Reference: License No: 24-21362-01

Subject: Reply to RFAI

American Radiolabeled Chemicals, Inc (ARC) is pleased to present the following information in response to your Request For Additional Information (RFAI) dated 9 July 2013.

Attachment 6

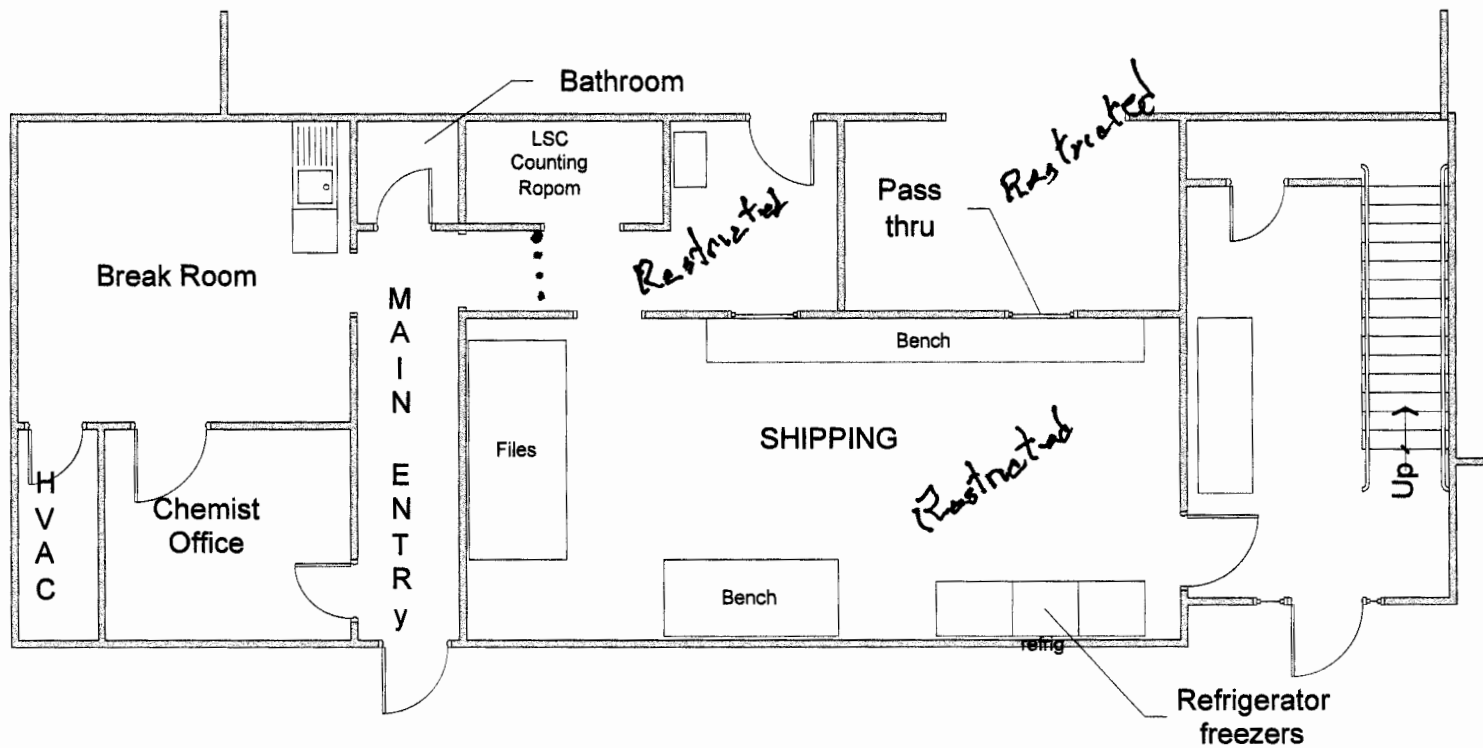
- 1. For each building where radioactive material may be received, please describe (through the use of a diagram) where the receipt and storage areas are located.***

All incoming mail and packages are delivered to the main office in Building 400. Any package marked as radioactive, as UN2910, or suspected of containing RAM is transferred to the RAM shipping area for survey, opening, inventory and issue to the chemist requesting the item.

See Attachment 6

**Building 100
ROOF TOP DUCTS**

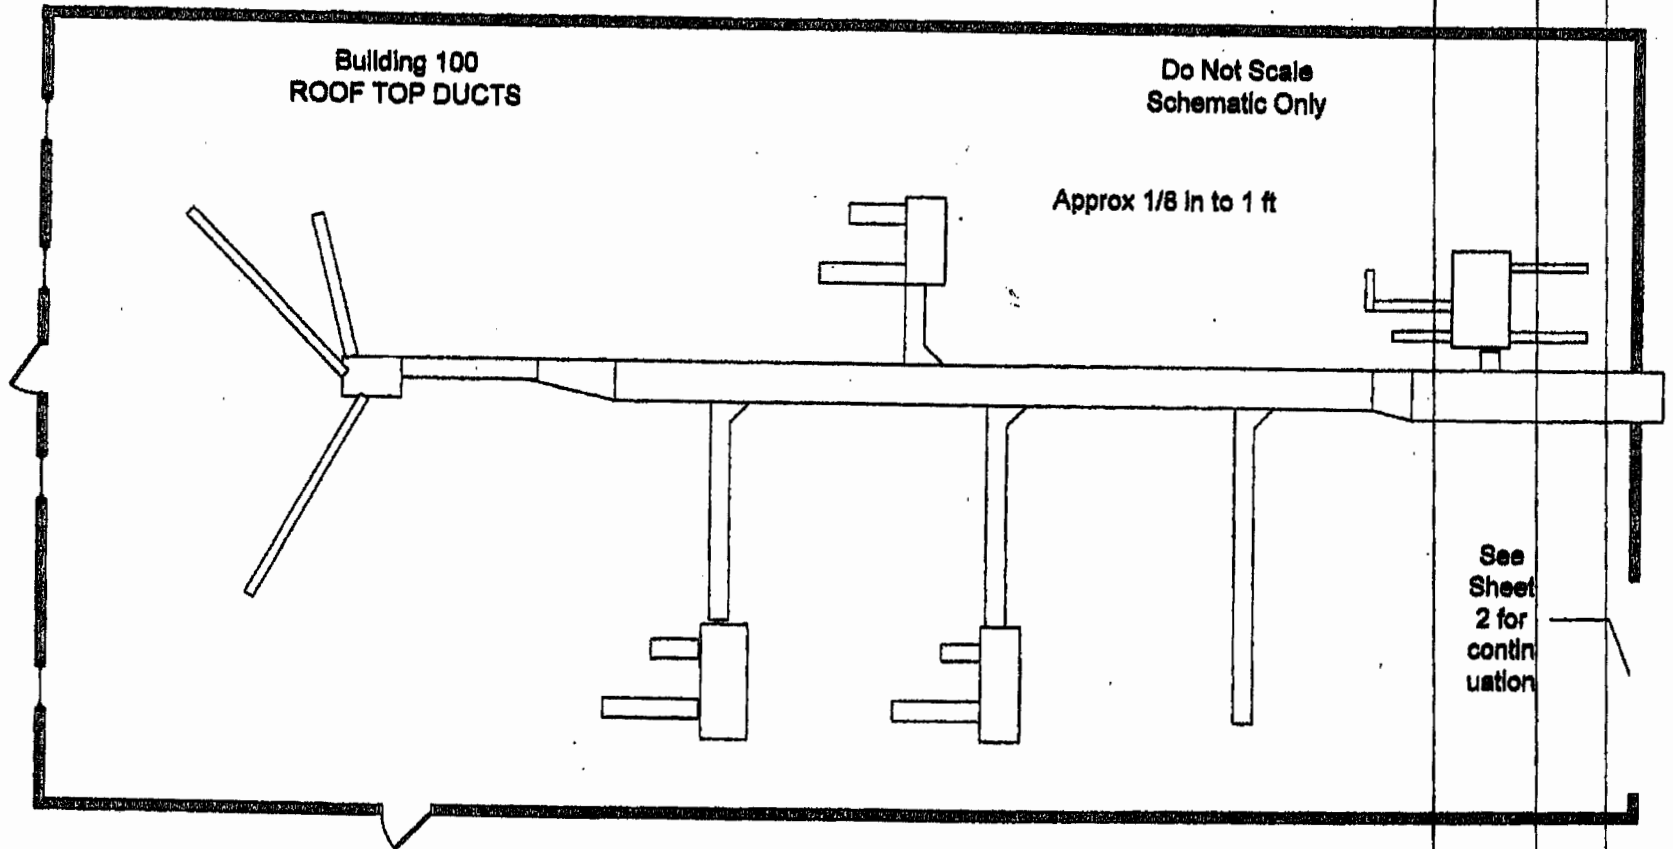
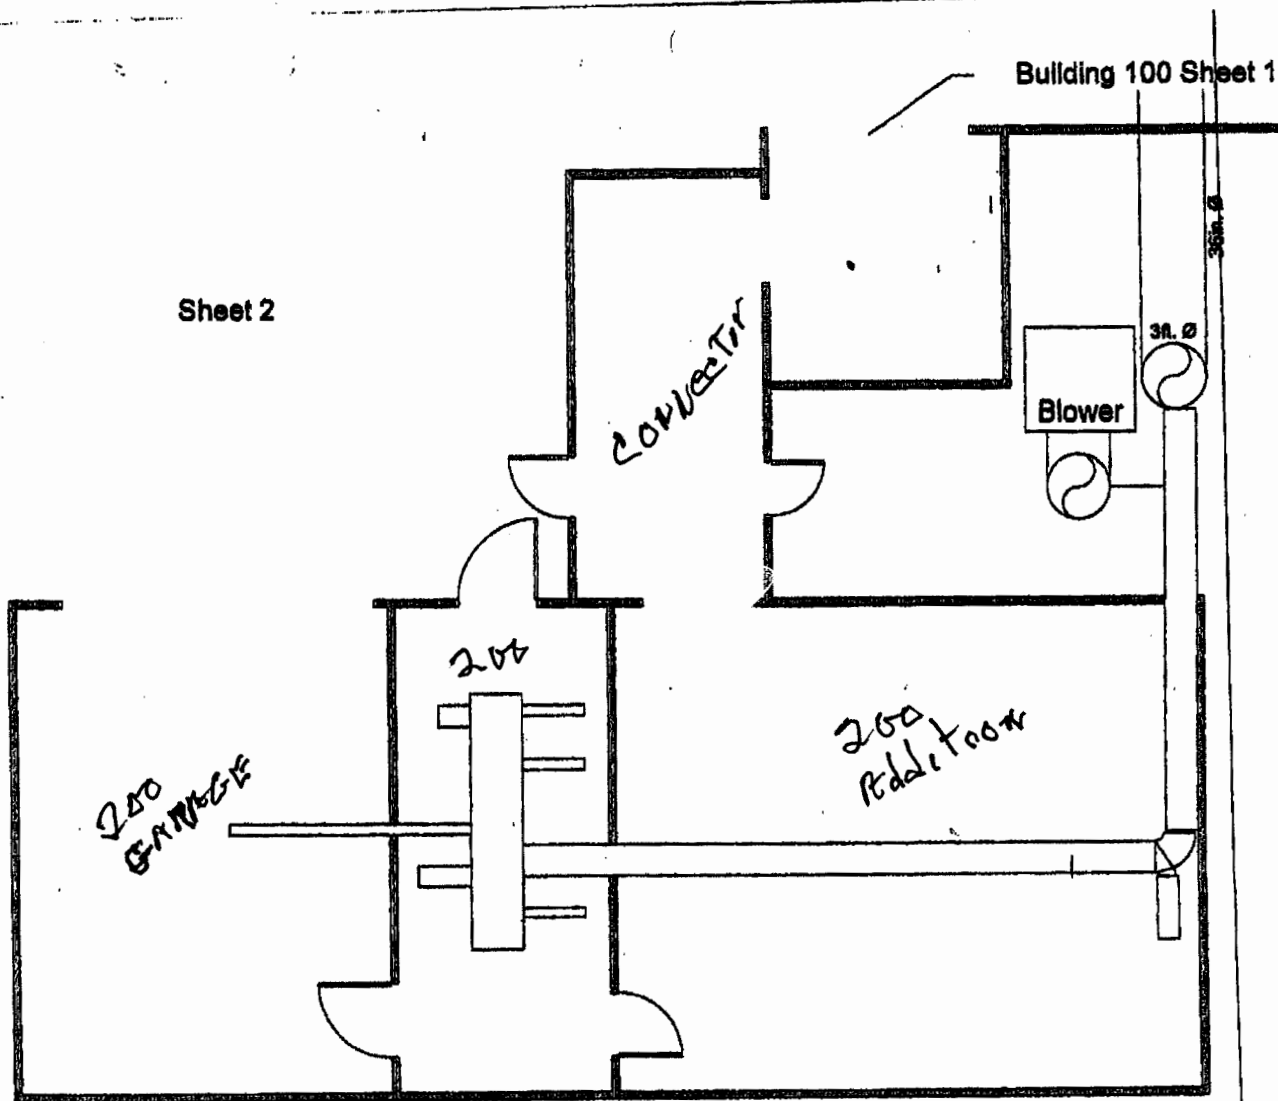
- 2. Submit a diagram of buildings 100 and 200 which illustrates the ventilation (air supply and exhaust systems) and how the system connect between the two buildings.***

Attachment 7, in two pages shows the exhaust system for building 100/200 (they are essentially one building). The makeup air ducting is parallel to the exhaust duct. The make up air enters the lab at each hood forming a vertical air curtain the width of the hood. This curtain flows down between the chemist and the hood and is then exhausted through the hood.

**Building 300 Roof
Consolidated Duct**

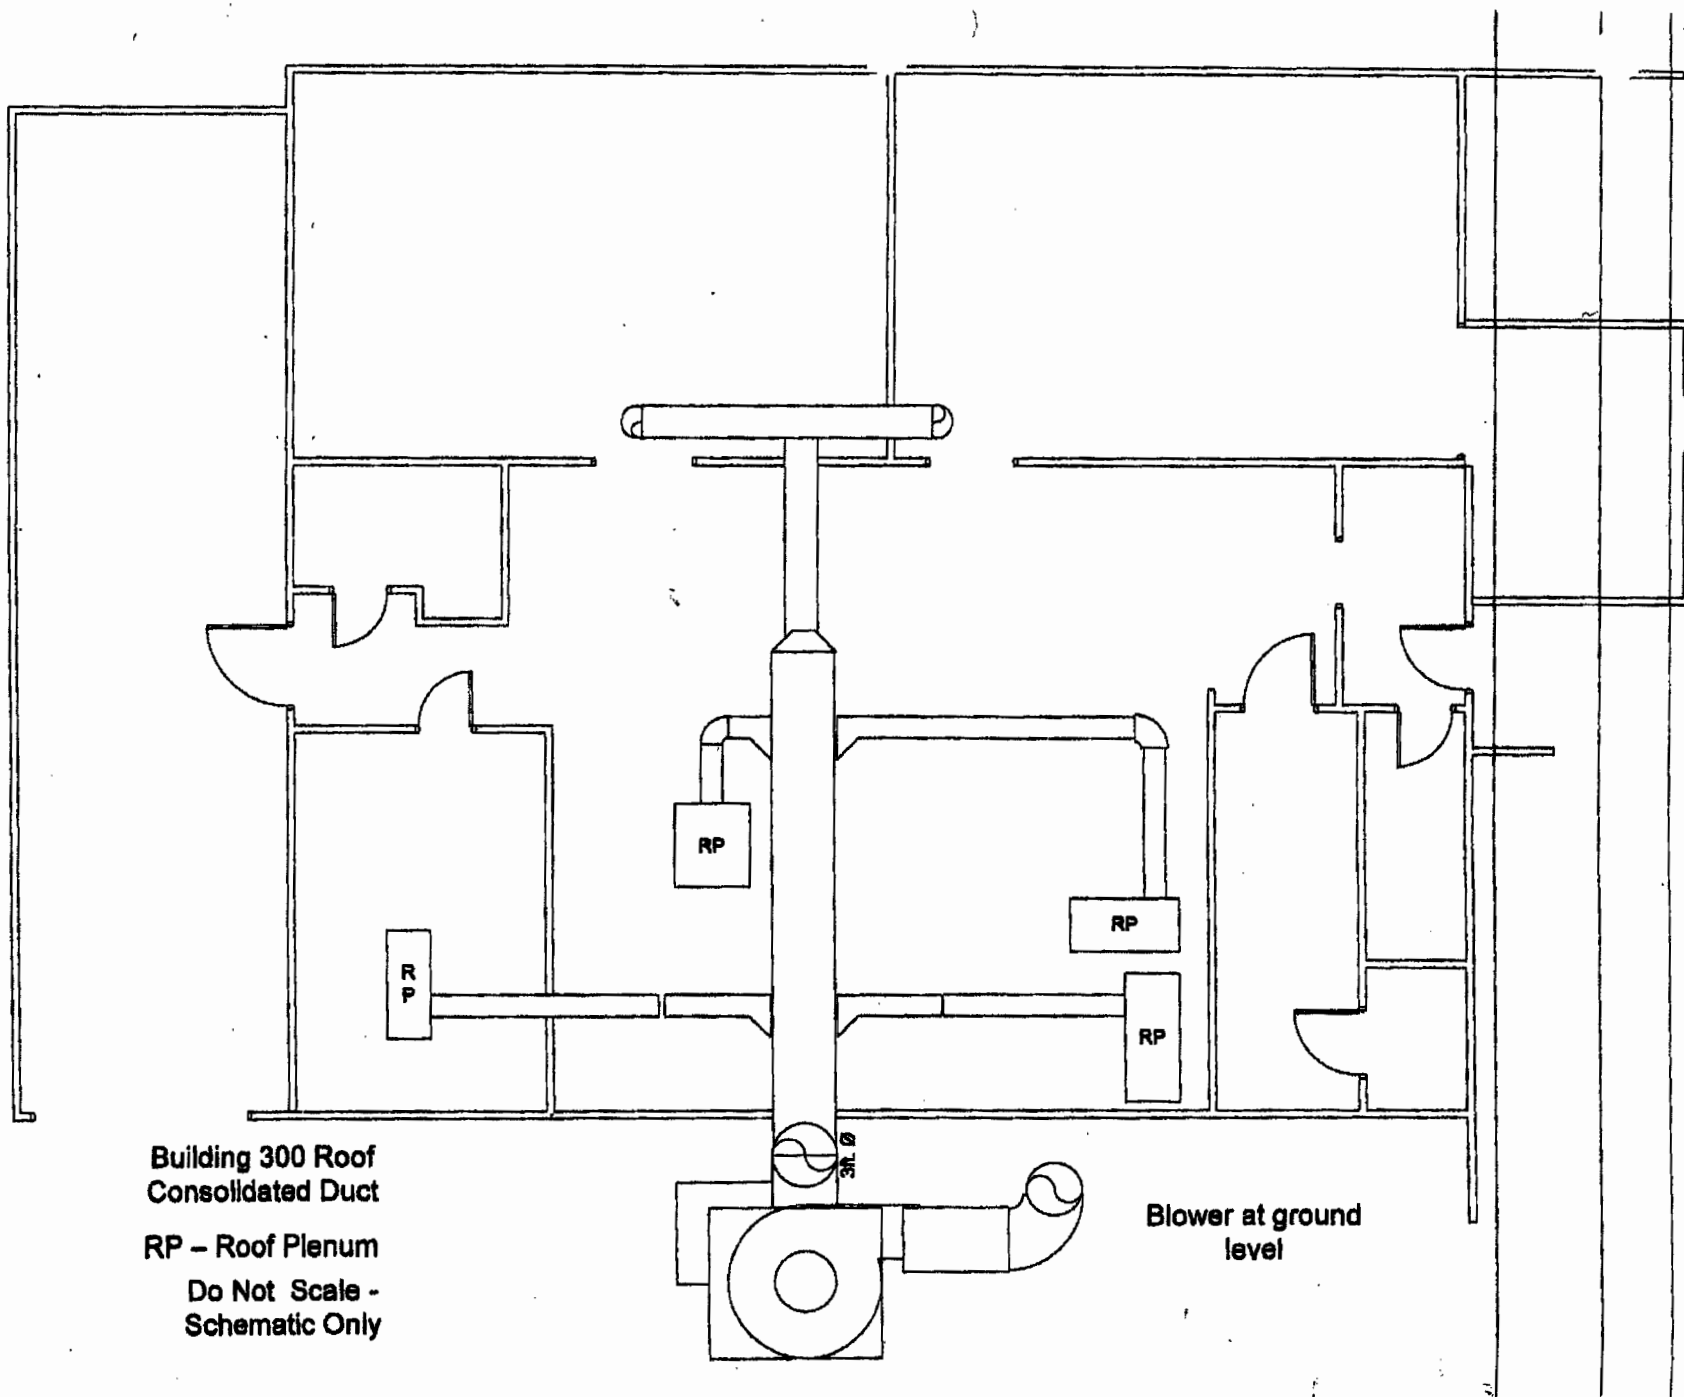
5. Describe the ventilation systems for building 300 and 300 annex.

Exhaust – Building 300, see Attachment 8
Annex RAM not in service , see Attachment 9
Annex RAM, not in service, see Attachment 9

Make-up Building 300, parallel to exhaust
Annex, not in service, see Attachment 9

Attachment 14

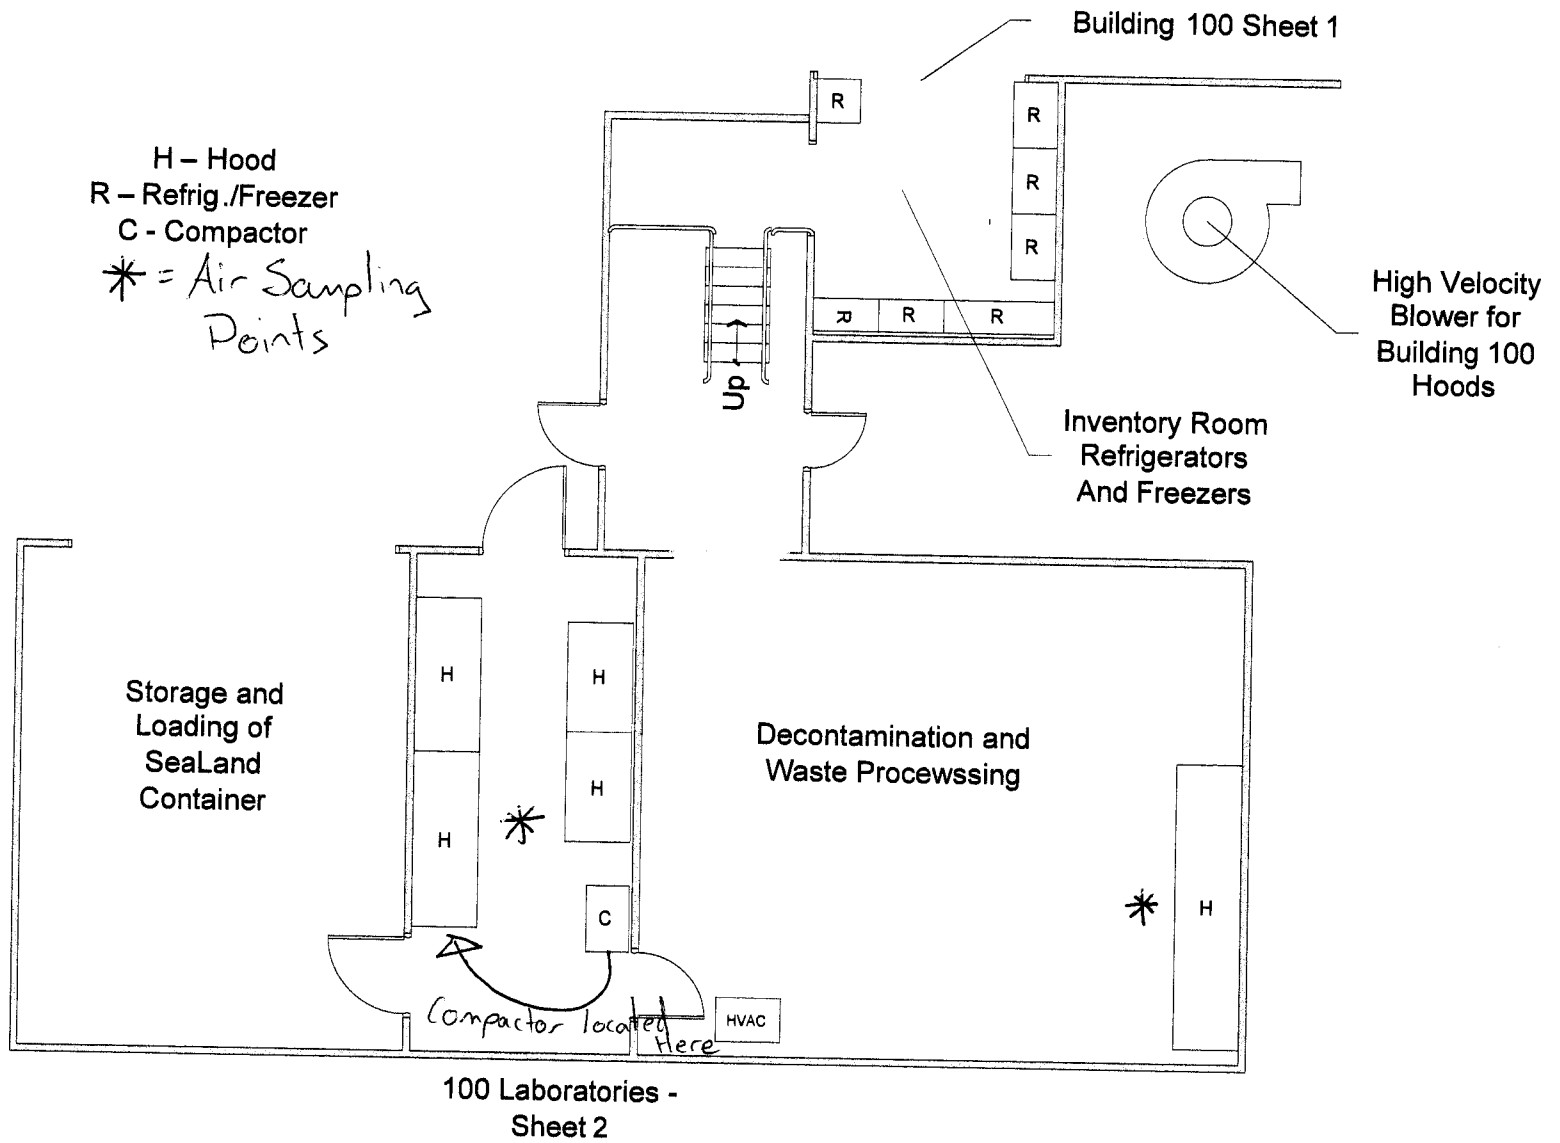
Identify the fume hoods where this process will take place (ref 1.4), and describe minimum fume hood flow rate that will be maintained and how you will verify that this flow rate will be maintained.

All evaporation hoods are located in B200. The exhaust system for these hoods is connected to main stack exhaust for the whole building. Air sampling takes place just after the blower engine but before the top of the stack. Air samples are taken 24 hours a day measured at week long intervals. These results are used in COMPLY to calculate our dose to the public. The evaporation area also has an air sampling point measuring the air concentrations for workers processing liquid waste. See attachment 14, Building 200 floor plan.

There are four hoods located in building 200. Each hood connected to main exhaust stack line. The minimum hood face velocity as required by the SOP's is 100 linear feet per minute. Everyday a walkthrough is performed in the morning and at night. During these times the face velocity is checked on all hoods including these four. Once a week a written record of the hood face velocities is taken, including specific flow rates and widths of the hood face. SEE attachment 14, Building 200 floor plan.
